**State Air Quality Control Plan**

**Alaska Regional Haze State Implementation Plan**

**Response to Federal Land Managers' Comments on Regional Haze Proposed Regulations**

March 30, 2022

## Haze Composition on Most Impaired Days

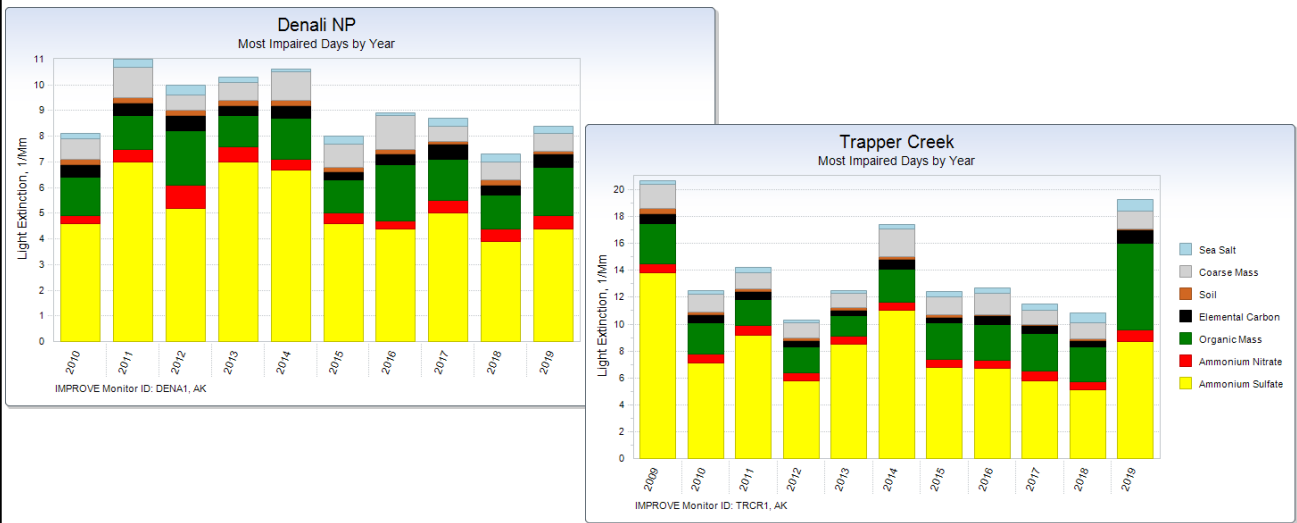
Alaska incorrectly identifies the Trapper Creek IMPROVE monitor (TRCR1) as the official IMPROVE monitor for Denali NP&P.

- The Denali Headquarters IMPROVE site (DENA1) is recognized by the NPS, EPA, WRAP TSS, and IMPROVE steering committee as the official monitor for this Class I area.
- The monitor has been in continuous operation 13 years longer than Trapper Creek and better represents the 2/3 of the park acreage located on the north side of the Alaska Range.
- Alaska should update the draft SIP to correct this error.

Response: DEC concurs that the Denali IMPROVE data should be included in the State Implementation Plan (SIP) in addition to the Trapper Creek IMPROVE data. The monitoring data and historic trends for that site have been added to the relevant sections of the plan consistent with prior plans. DEC and the NPS do disagree about which IMPROVE site, Trapper Creek or Denali, is the primary IMPROVE site for regional haze purposes, but this disagreement does not prevent the state from displaying all the relevant data for the Class I area in the SIP, DEC has always identified in the Regional Haze SIP that the IMPROVE site purposefully installed at Trapper Creek to monitor for regional haze is the primary monitor for purposes of the state's SIP planning and regional haze monitoring network as described in Section K.13.C (Monitoring Strategy). In response to the ongoing disagreement related to which site is the primary IMPROVE site for the Denali Class I area for purposes of regional haze planning, DEC is conducting further analysis and assessment of the two monitoring locations, TRCR1 and DENA1, to further document this issue and the State's position. DEC plans to share that analysis with the Federal Land Managers and EPA upon its completion.
